**HISTORIC LANDMARK COMMISSION**  
**APPLICATION FOR A CERTIFICATE OF APPROPRIATENESS**  
**JULY 26, 2021**  
**C14H-1974-0006; HR-2021-100814**  
**PAGGI HOUSE**  
**200 LEE BARTON DR.**

Replace existing butterfly roof and construct glass walls between the buildings to fully enclose the courtyard.

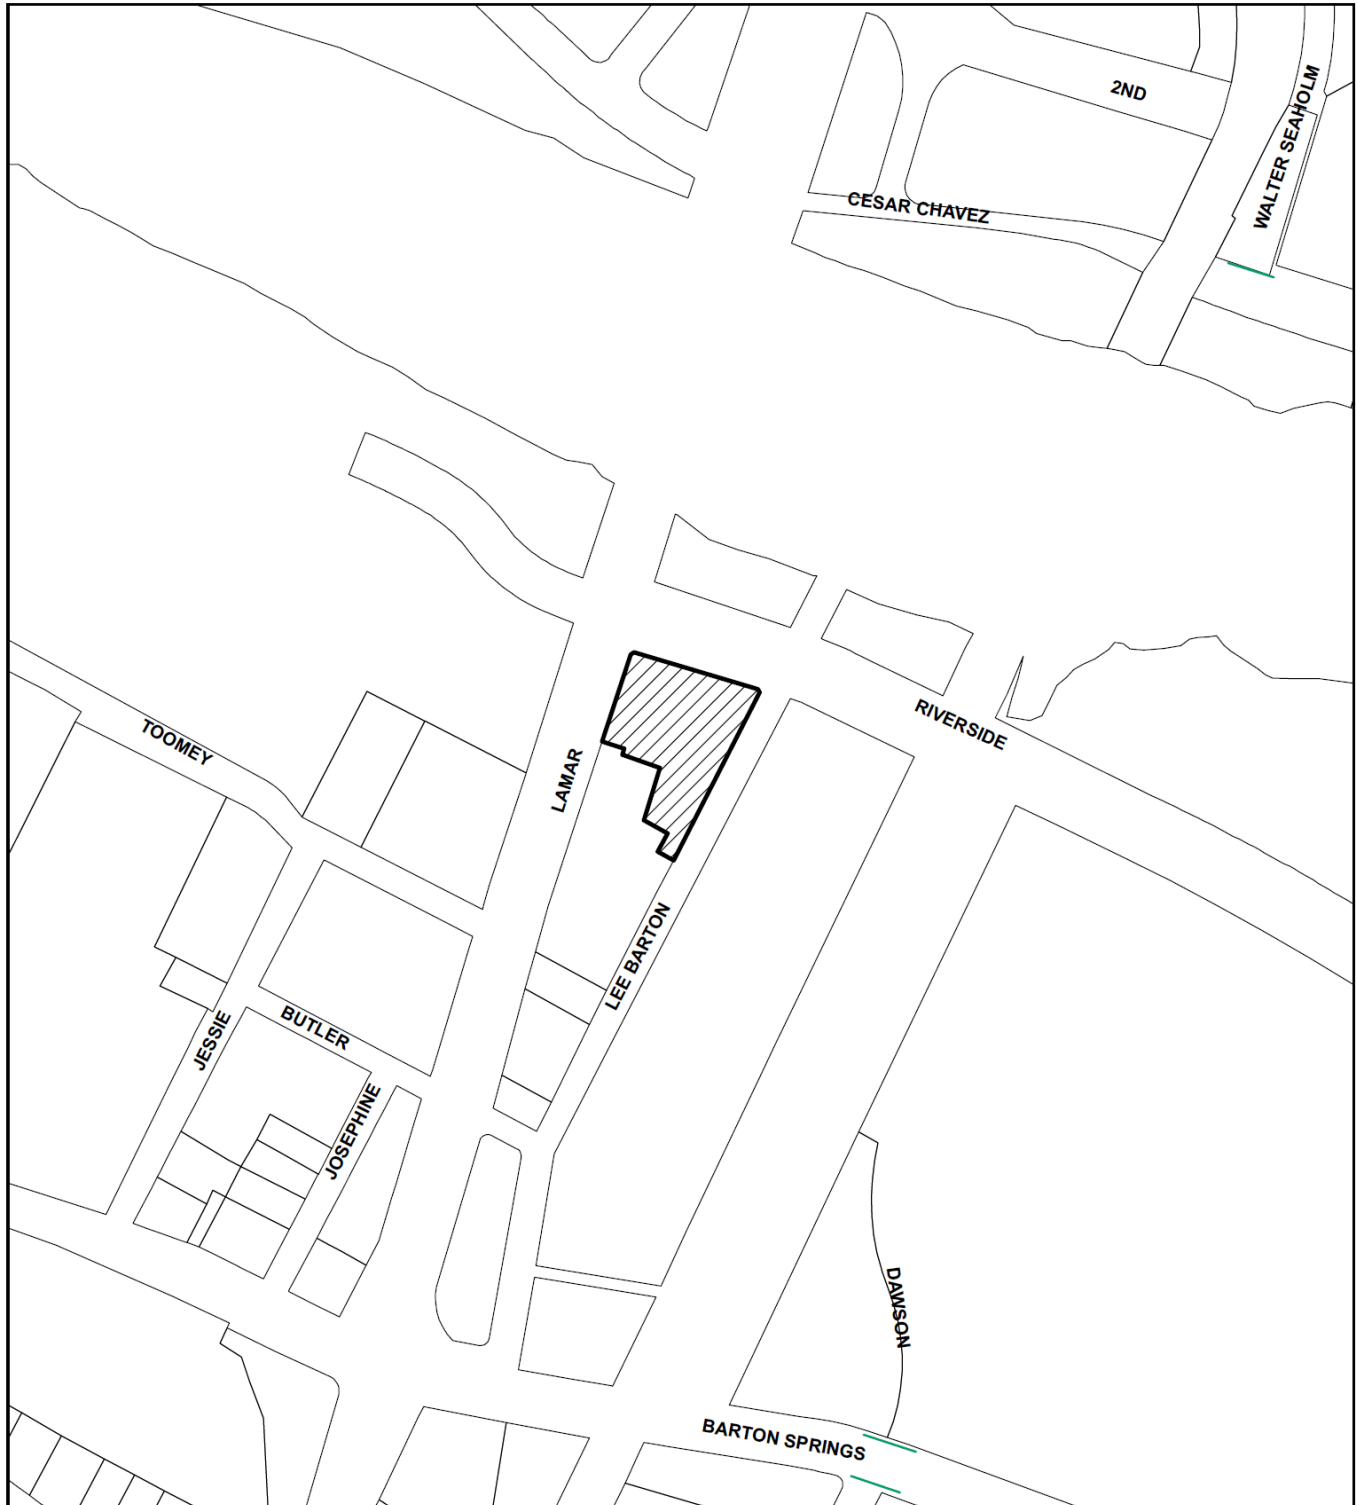
Committee members found the approach sensitive but advised caution in working around the historic buildings, with attention to how conditioned air would affect historic masonry.

Approve the application.
